LANDSCOPE (MAURITIUS) LTD
INFRASTRUCTURE WORKS AT COTE D'OR
REF No.: LM-CD-AP24-150

ADDENDUM NO. 4

Date: 07th June 2024

Drawing number:
23140-TD-3TP113

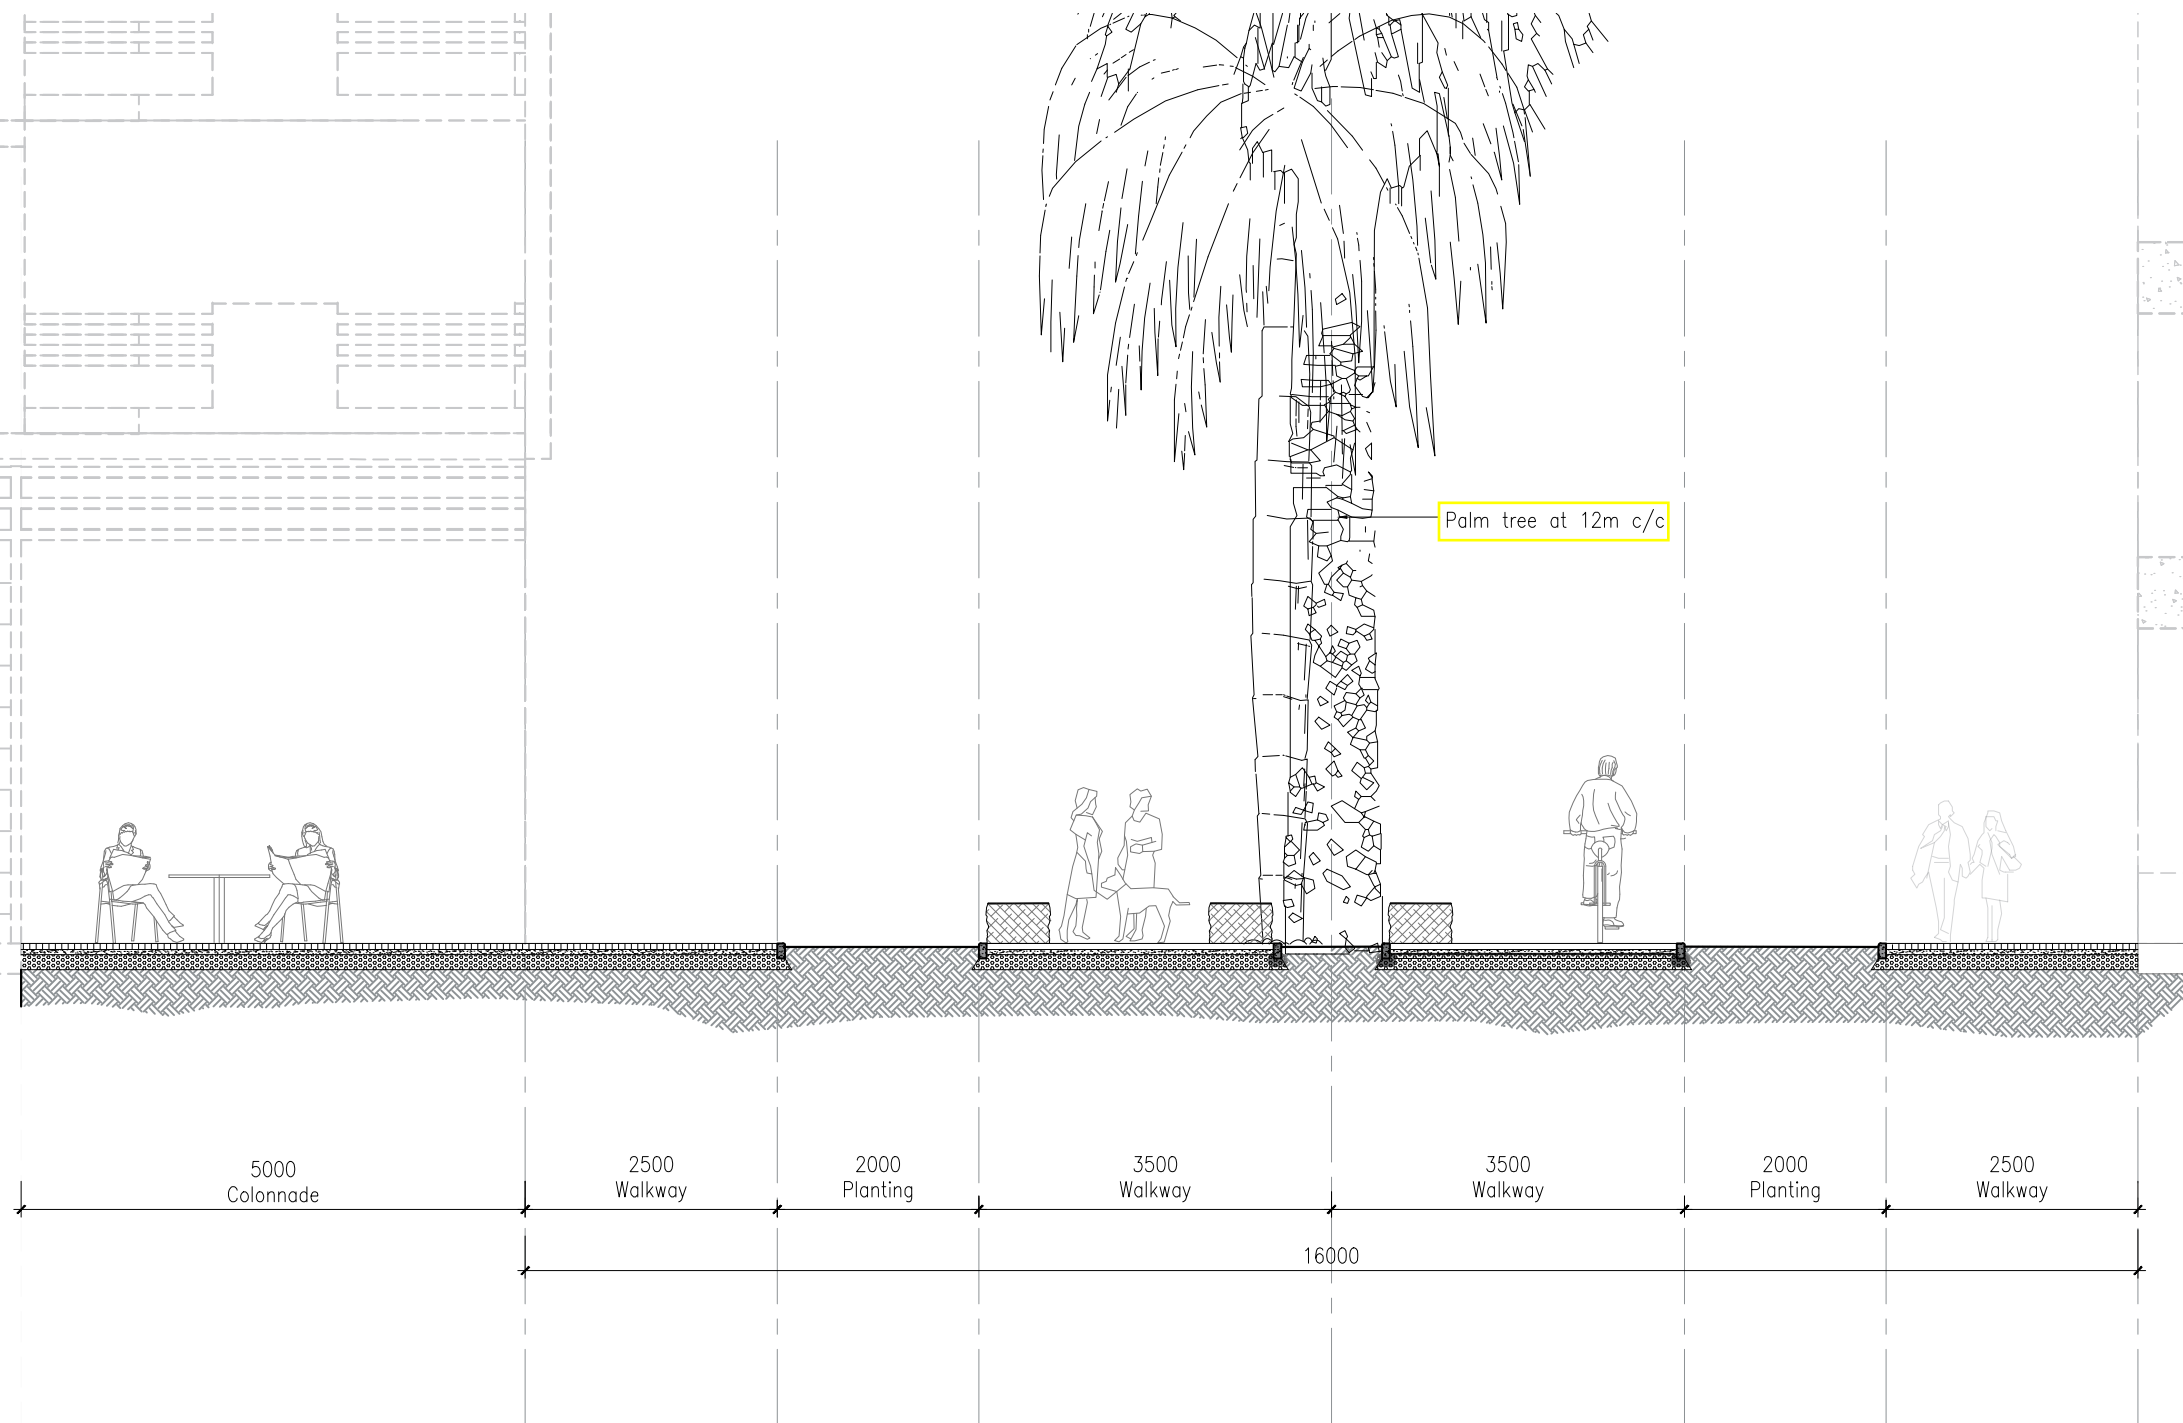
SN	Original Queries by Bidders	Reply from Employer
7.	We refer to the above-mentioned tender and would be grateful if you could provide the typical road cross-sections across walkway 1, walkway 2 & metro line	Bidders are hereby informed that 23140-TD-3TP113 and 23140-TD-3TP114 now forms part of volume 3 of 3 of the bidding documents as enclosed in Annex A
